# **Final Independent External Peer Review Report for the Savannah Harbor Expansion Project General Reevaluation Report**

Prepared by  
Battelle Memorial Institute

February 11, 2011

**Figure 1 - Time series of flow data (as cubic meters/second) assigned for the Savannah Withdrawal in the EFDC extended grid model to represent the City of Savannah water intake. Flow boundary data plotted with EFDC\_Explorer5 (Craig, 2010).**

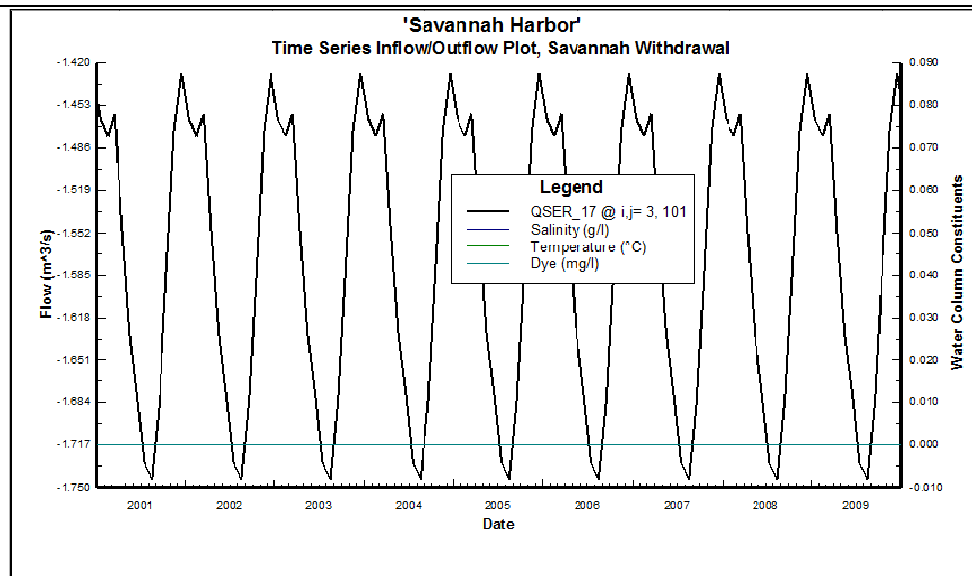
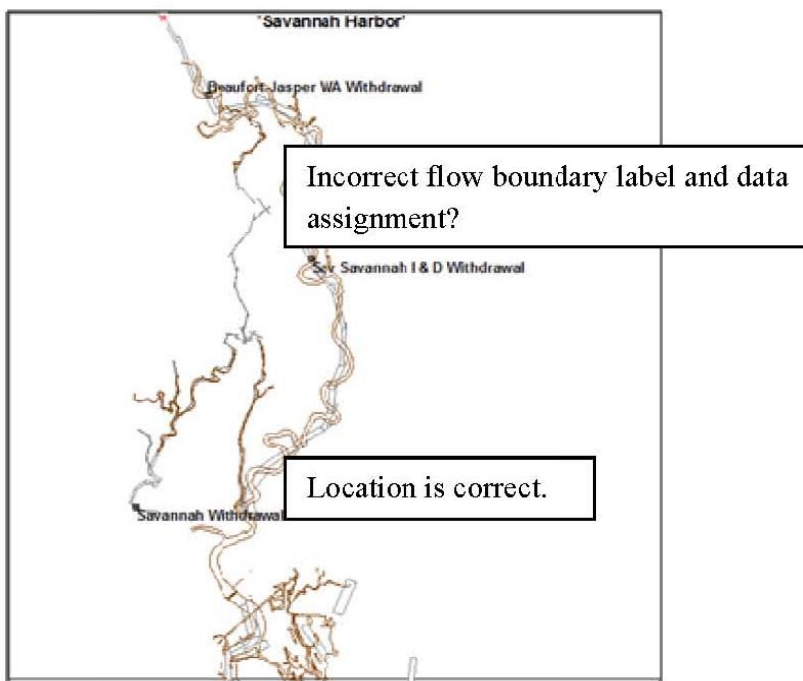
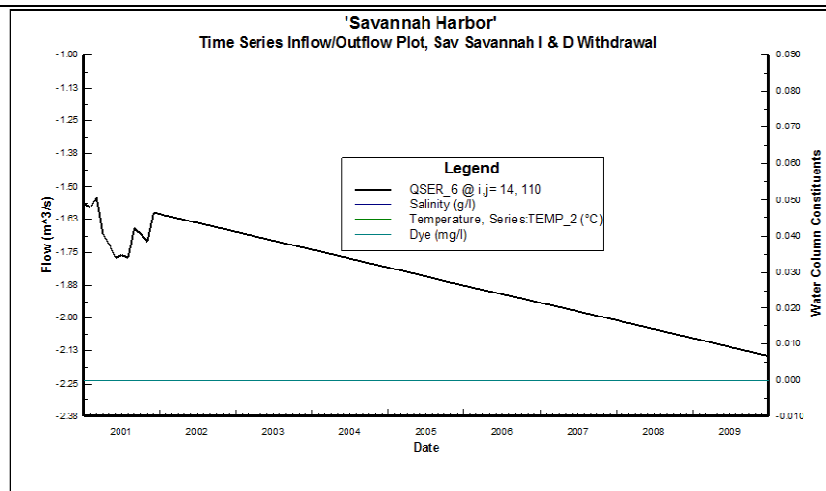
The first issue related to the flow rate data used to represent the water intake in the extended grid model is the data presented in the report as the maximum capacity of the facility and the absence of documentation of the data source used to assign withdrawal data in the model for the water intake. In Section 2.0 of the Chloride Modeling Report, the existing maximum capacity of the City of Savannah Industrial and Domestic (I&D) water treatment plant is reported as 75 million gallons per day (MGD). The report also states that the capacity of the water treatment plant was 35 MGD when the facility was constructed in 1947. In comments dated 24 January 2011, submitted to the USACE, the City of Savannah informs USACE of the distinction between the actual production volume and maximum capacity of the plant. The City states that the production volume is “roughly 30 MGD,” while the “capacity of the plant has been 62.5 MGD since its expansion in 1998”. The withdrawal data used in the EFDC model to represent the water intake on Abercorn Creek, shown in Figure 1, suggests that the average withdrawal rate of 1.57 cubic meters/second (equivalent to 35.8 MGD) is, perhaps, based on the 35-MGD capacity of the original plant rather than the existing production volume of 30 MGD.

A second extended grid model issue related to the flow data used to represent the City of Savannah water intake is the assignment of a flow boundary identified as Savannah I&D Withdrawal on the Savannah River. Flow boundary locations are provided in the EFDC input files for the extended grid model. EFDC\_Explorer5 (Craig, 2010) was used to display the flow boundaries in the vicinity of Abercorn Creek. Figure 2, prepared with EFDC\_Explorer5, shows the correct location of the Savannah Withdrawal on Abercorn Creek. Figure 2, however, also shows a location for a flow boundary identified as Savannah I&D Withdrawal on the Savannah River. Figure 3, prepared with EFDC\_Explorer5, shows the time series data assigned for the Savannah I&D Withdrawal. It appears that there is an error in the model setup, since the withdrawal that is located on the Savannah River is most certainly not the Savannah I&D withdrawal on Abercorn Creek.

1. Revise the information and data presented in Section 2.0 of the Chloride Modeling Report to clearly document, and distinguish, the existing maximum capacity of the plant and the actual production volume recorded at the plant during the model simulation period of 2001-2009. Document the source of the data shown for the time series withdrawal flows (Figure 1) in the report.
2. Either delete the apparently erroneous Savannah I&D withdrawal location on the Savannah River from the model setup or replace it with the correct label and flow data for the flow boundary at this location.
